Rezoning Transportation Analysis

Petition Number: 2020-026

General Location Identifier: Tax ID04940106

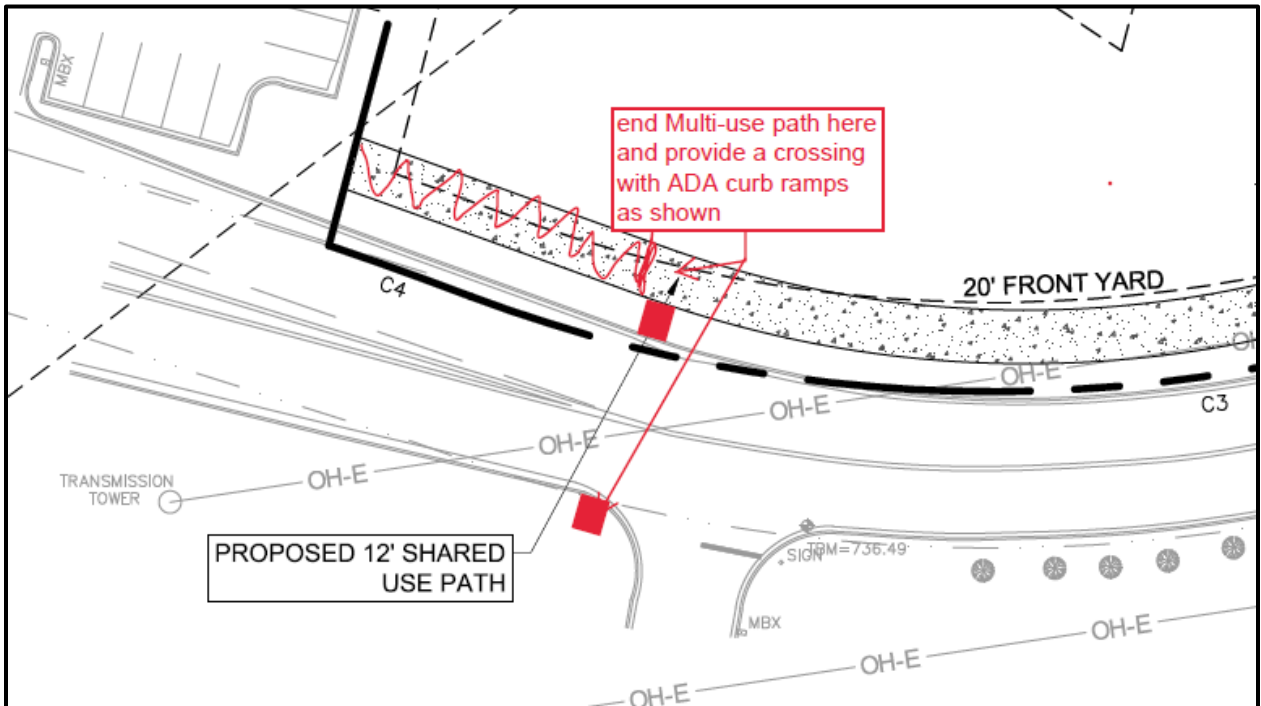
5. The petitioner should revise the site plan and conditional note(s) to align the proposed street and driveways across the street to provide a safer access. (Revised on 04-17-220)

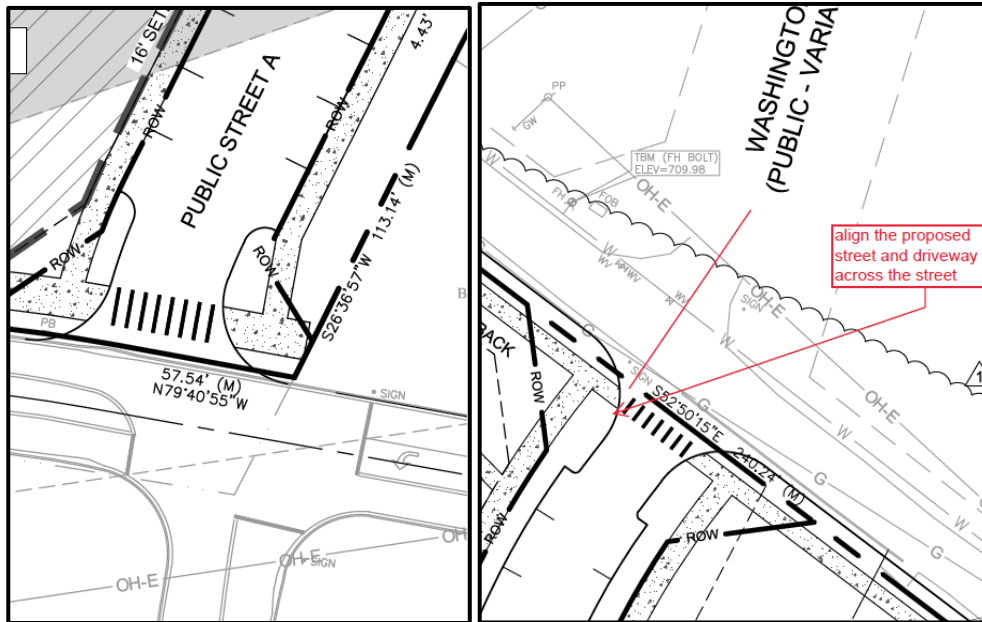
6. The petitioner should revise the site plan to add a note specifying dedication and fee simple conveyance of all rights of way to the City before the site's first building certificate of occupancy is issued. CDOT requests right of way set at 2' behind back of sidewalk where feasible.
7. The petitioner should revise the site plan to add a note specifying all transportation improvements will be approved and constructed before the site's first building certificate of occupancy is issued. The petitioner may phase transportation improvements if said improvements and phasing are explicitly described in site plan notes.
8. **Resolved** - Sample format for comment that is resolved
